Project	<b>IEEE 802.16 Broadband Wireless Access Working Group</b> < <a href="http://ieee802.org/16">http://ieee802.org/16</a> >	
---------	--	--

Title	<b>Effective utilization for packing and fragmentation subheader</b>	
-------	--	--

Date Submitted	<b>2004-05-10</b>	
----------------	-------------------	--

Re:	This contribution is response to call for contribution about IEEE802.16e-D2	
-----	---	--

**Figure 1 "Packing information within a single MAC PDU"**

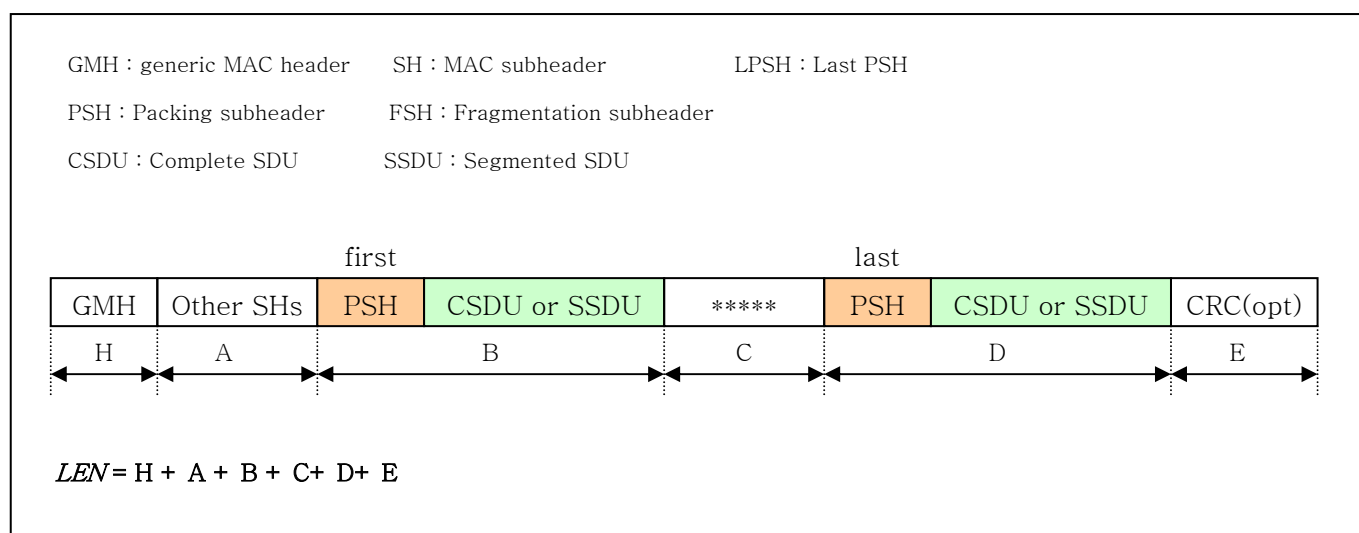
In figure1, all of the PSHs within a single MAC PDU contain 11bits 'length' field. This 'length' field is used for addressing individual beginning of each CSDU/SSDU within the same MAC PDU.

Problem is the 'length' field in the last PSH within a single MAC PDU. Receiver can calculate the size of the last CSDU/SSDU without the corresponding PSH's 'length' field. Therefore, when fragmentation and packing are allowed within the same MAC PDU, the last packing subheader in that MAC PDU can be replaced with an appropriate fragmentation subheader.
